**STAFF REVIEW AND RECOMMENDATIONS
PUBLIC HEARING
JANUARY 20, 2021**

ABBREVIATED PLAT: SHIRE ESTATES

REVIEWED BY: CHERYL SCOTT CASE: 2020-191

Shire Estates / Resub L9 B2 Snowshoe East
Useable Area, Drainage and Topography Map

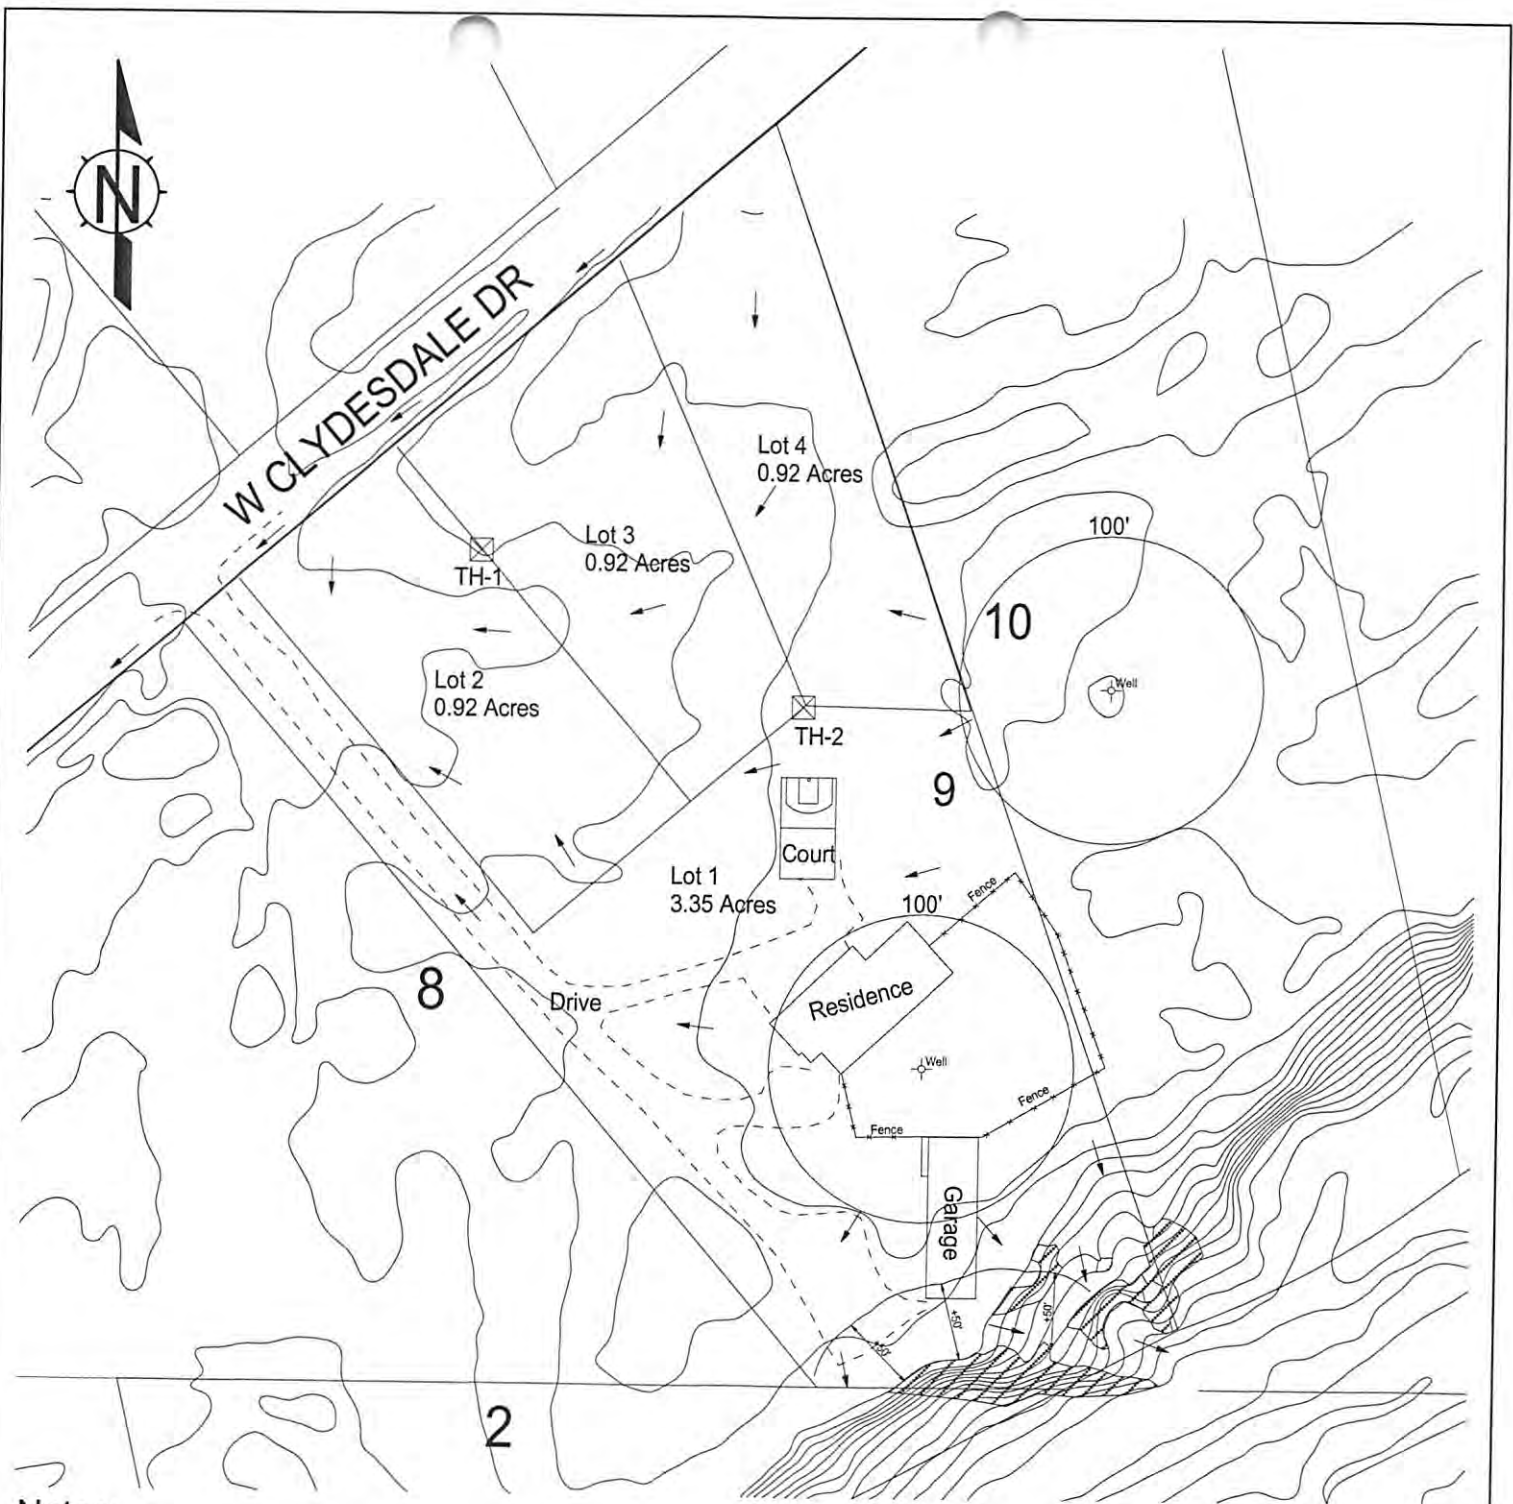
Useable Area: Holler Engineering performed a soils evaluation including two new testholes, review of the topography, aerial imagery and other observations on site. The soils report includes the testhole logs and a testhole location map. **(Exhibit C)** The property consists of a minor slope towards the west and north with a total elevation differential of approximately 26 feet. A few minor steep areas with slopes exceeding 25% are shown on the attached map. The property contains cleared areas related to the existing residential structures and the remaining area consists primarily of tall grasses, willows and scattered birch trees. The testholes were excavated to 12 feet and groundwater was not encountered. Near surface soils included a thin organic mat and silty topsoil over consistently clean sand and gravel. Based on the available soils and water table information, topography, MSB Title 43 Code definitions and observations on site, the proposed lots will each contain over 10,000 sq. ft. of contiguous useable septic area and 10,000 sq. ft. of useable building area consistent with MSB 43.20.281, *Area*.

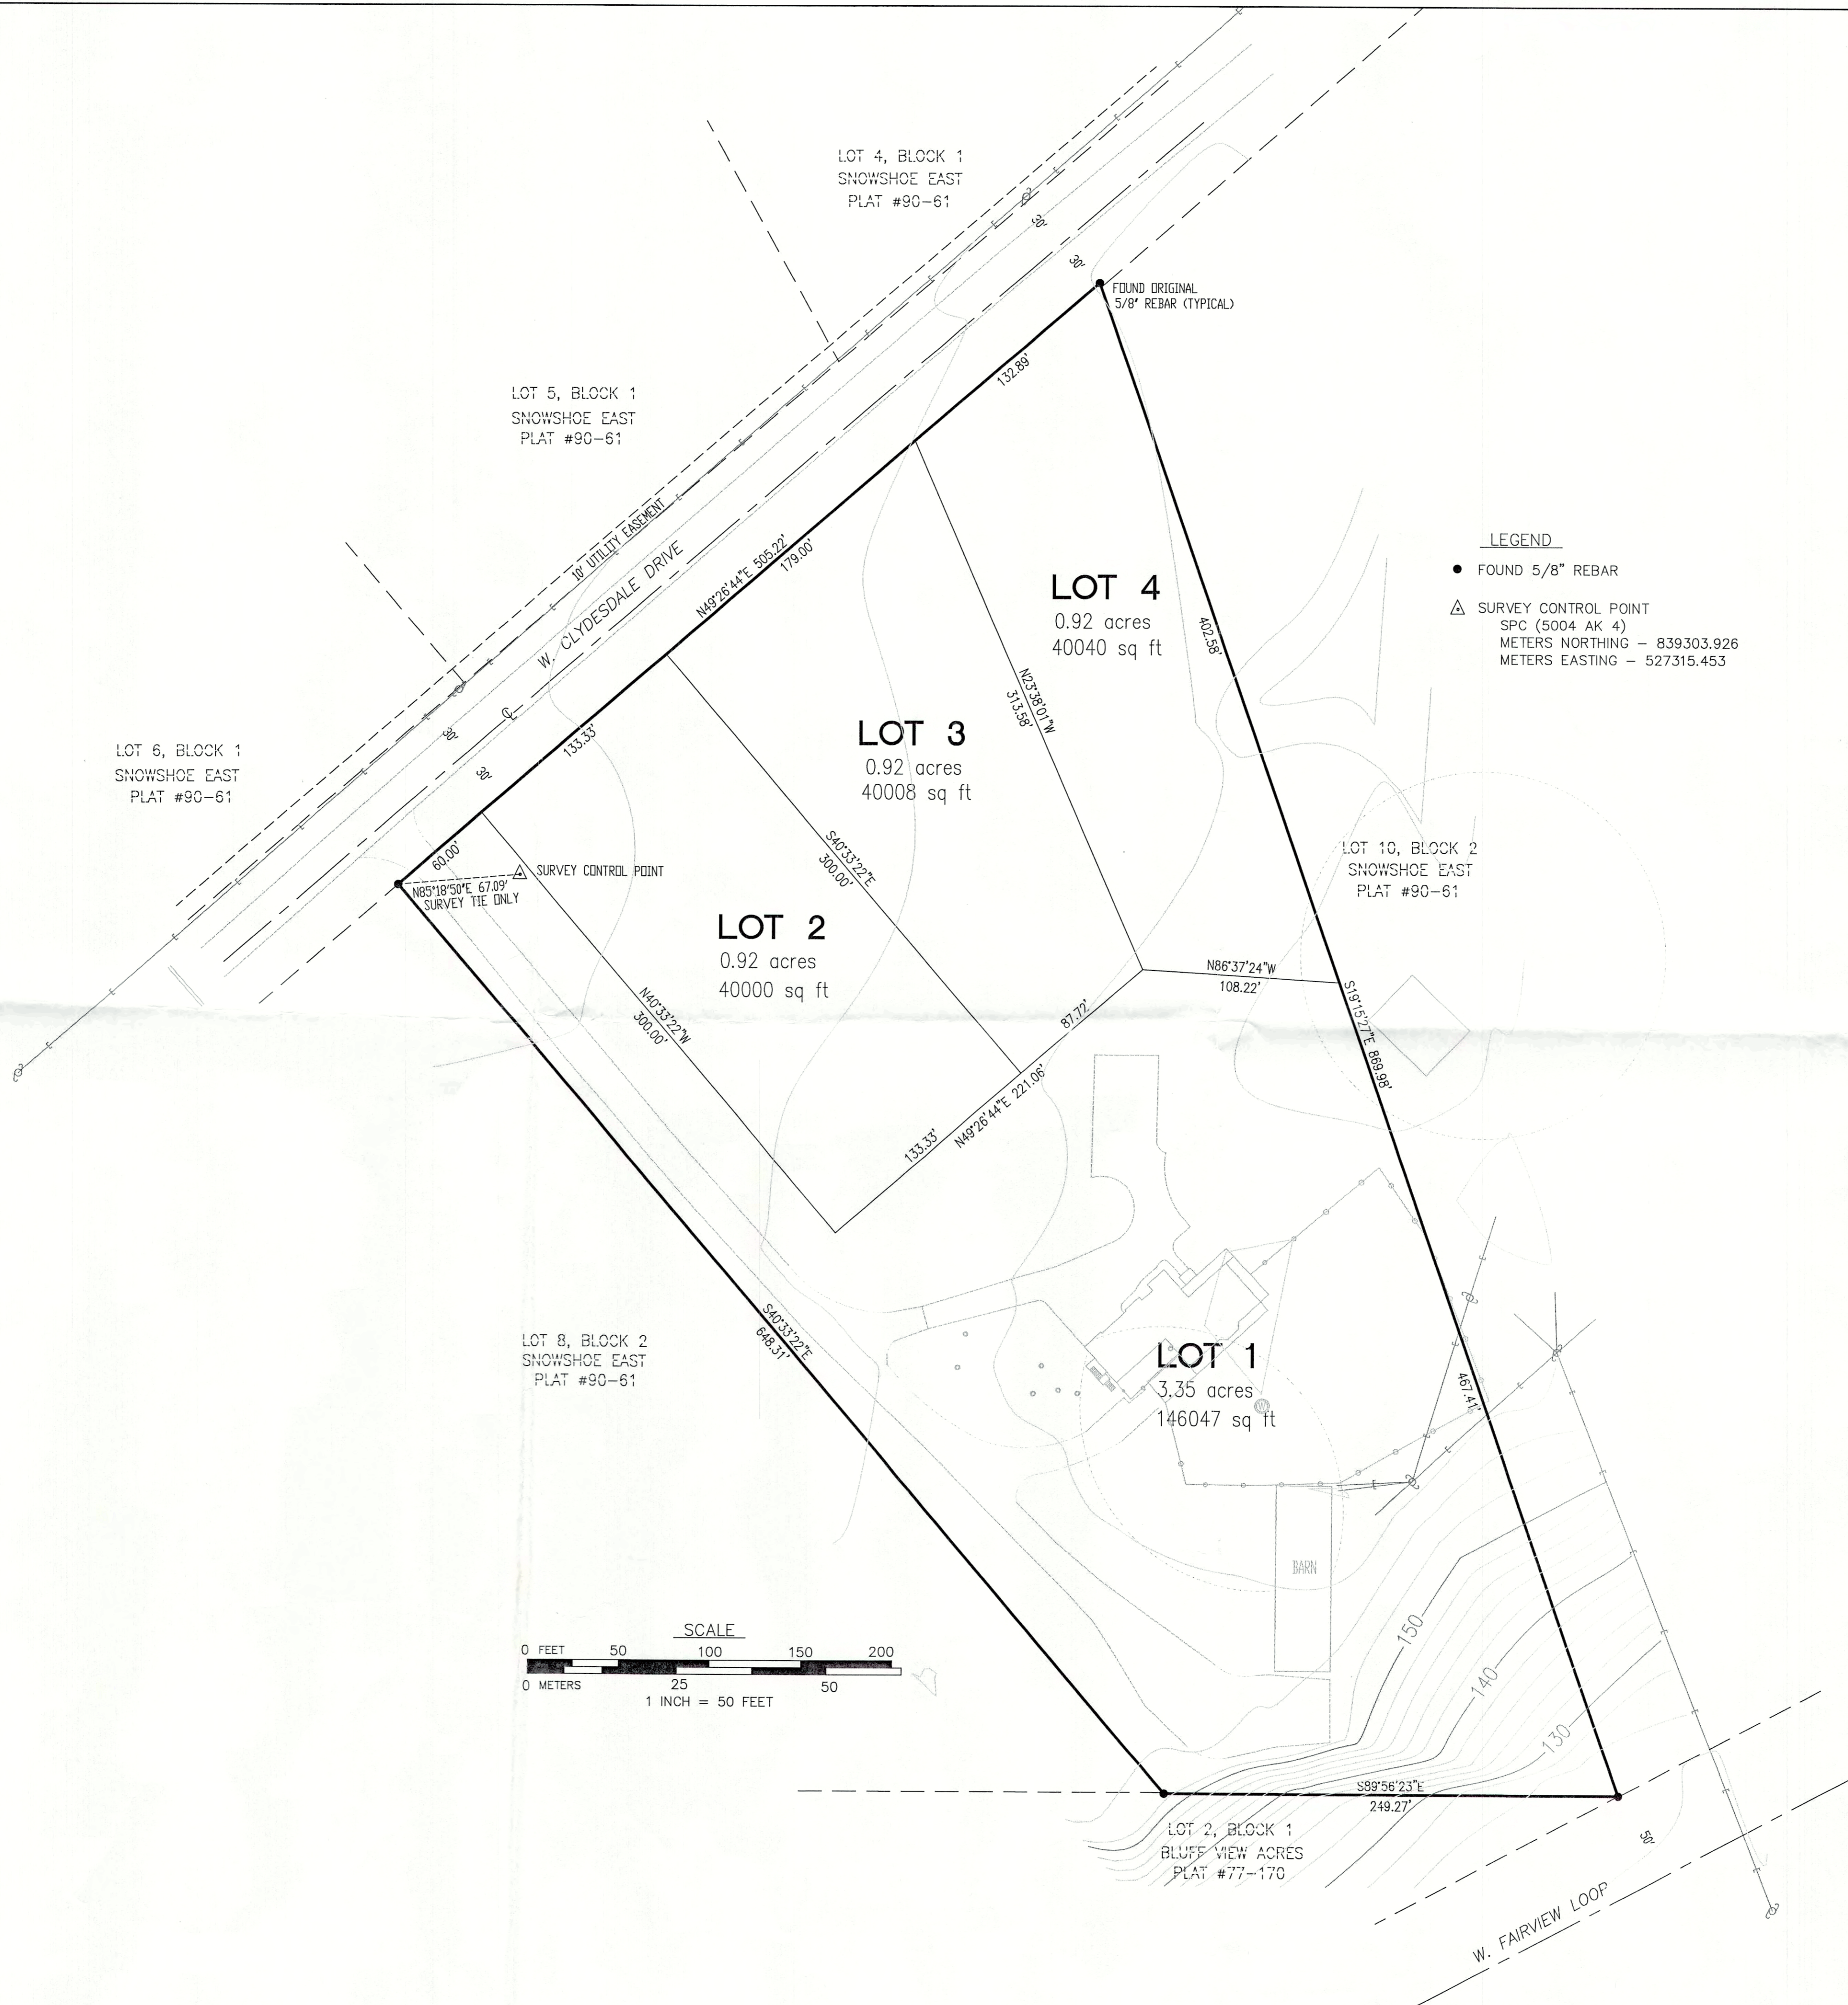
Lot & Block Design/Frontage: MSB 43.20.300, *Lot and Block Design* states lots under 2 acres in size shall have an average depth of no more than 3 times the average width. Lot 4 does not appear to meet this requirement and will need to be adjusted on the final plat to comply with code. **(Recommendation #5)** The other lots meet Lot and Block Design requirements.

Platting Officer noted Lot 4 appears to have a width to depth issue. **(Exhibit D)** See *Recommendation #4*.

Fire Code said it would be easier to access Lot 1 from Fairview Loop rather than the proposed pole section of the flag lot. **(Exhibit H)** *Staff notes ADOT&PF will not grant direct access to Fairview Loop and residential access onto a major collector is not recommended when access to a lower classified street is available.*

ADOT&PF will not grant direct access to Fairview Loop. All lots must access Clydesdale Drive. **(Exhibit I) (Recommendation #7)**

Lot four appears to have a width to depth issue. The width is approximately 115 feet and the average depth is 358 +/-.

It would be easier to access lot 1 from Fairview Loop rather than the proposed pole section of the flag created.

4. Provide a final plat correcting the boundary to reflect the Fairview Loop Rehabilitation Road Project Right-of-Way Acquisition along with adjusted acreage.

5. Adjust necessary lot lines so all lots meet the depth to width ratio consistent with MSB 43.20.300 *Lot and Block Design* and show on the final plat.

6. Apply for driveway permit for existing driveway from MSB Permit Center and notify Platting.
7. Add a plat note stating no direct access for any lot will be granted to W. Fairview Loop unless otherwise permitted by the permitting authority.
